NOTICE OF NON-PERFORMANCE

INSPECTION REPORT

Electrical Corporation:	Southern California Edison Company
Report Number:	NON_PAD_SCE_YLO_20260826_1436
Inspector:	Yana Loginova
WMP Year Inspected:	2026
Quarterly Data Report (QDR) Referenced:	Quarter 1 (Q1)
Inspection Selection:	Energy Safety viewed the contents of the Q1 QDR and performed an analysis that resulted in the selection of the WMP initiatives and locations referenced in this report.
Relevant WMP Initiative(s):	8.3.1 Distribution High Fire Risk-Informed (HFRI) Inspections - Ground and Aerial (IN-1.1)
Date of Inspection:	August 26, 2026
City and/or County of Inspection:	Chino Hills, San Bernardino County
Inspection Purpose:	Assess the accuracy of Southern California Edison Company's QDR data, completeness of its work, and performance of WMP requirements.

Asset Image 1: View showing buried anchor	**Asset Image 2**: View showing buried anchor

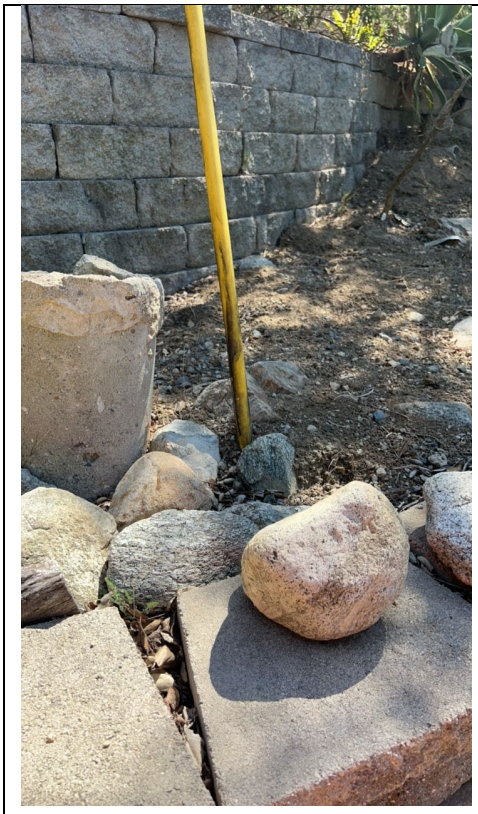
At this location, the inspector observed that anchor was buried. The inspector's observation is documented in Deficiency 1 photographs, which are attachments to this report. Photo numbers Asset Image 1, Asset Image 2, Asset Image 3, and Asset Image 4, depict buried anchor.

1. Southern California Edison Company reported that work related to a buried anchor at the location was completed under SCE's 2026 WMP initiative number 8.3.1 - Distribution High Fire Risk-Informed (HFRI) Inspections.
2. The anchor was found buried at the inspection location.

Deficiency 1. Energy Safety observed that in implementing 2026 WMP initiative 8.3.1 Distribution High Fire Risk-Informed (HFRI) Inspections - Ground and Aerial (IN-1.1), SCE failed to complete the remediation of buried anchor in a customer's backyard garden on Structure ID 517907E, Grid Hardening ID 413658337-517907E at coordinates 33.9570795865286, -117.767951189578. Energy Safety considers this non-performance to be in the Minor risk category. SCE must complete a corrective action for this deficiency by 12 months from the date of this notice.[1]
